West Seattle Junction Park

ADDENDUM NUMBER 2

July 10, 2026

Attachment #1	Section 26 56 00 Exterior Lighting
Attachment #2	Sheet E1.0 Power and Lighting Site Plan
Attachment #3	Sheet E1.2 Electrical Details and One-line Diagram

6 EVENT POLE MOUNTING DETAIL

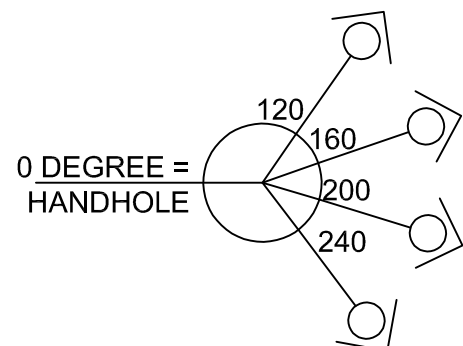
ITEM #2: **Question:** Plan number notes #1, 2 on E1.0 and within the fixture schedule on E1.1 note lighting control components from Echelon are to be installed. It's to my understanding the Echelon product line was factory discontinued and are these components confirmed to be available?

Answer: Change Lighting control and configuration on Sheets E1.0 and E1.02, see attachments.

- 1 SCHEDULED LUMINAIRE(S) AT 0°, 90°, 180° AND 0°. ATTACH DIRECTLY TO POLE. REFER TO FIXTURE SCHEDULE FOR ACTUAL FIXTURE DIMENSIONS, WATTAGE, FINISH, HARDWARE, ACCESSORIES, ETC.
- 2 STRAIGHT POLE.
- 3 HAND HOLE. REFER TO FIXTURE SCHEDULE FOR ORIENTATION INFORMATION.
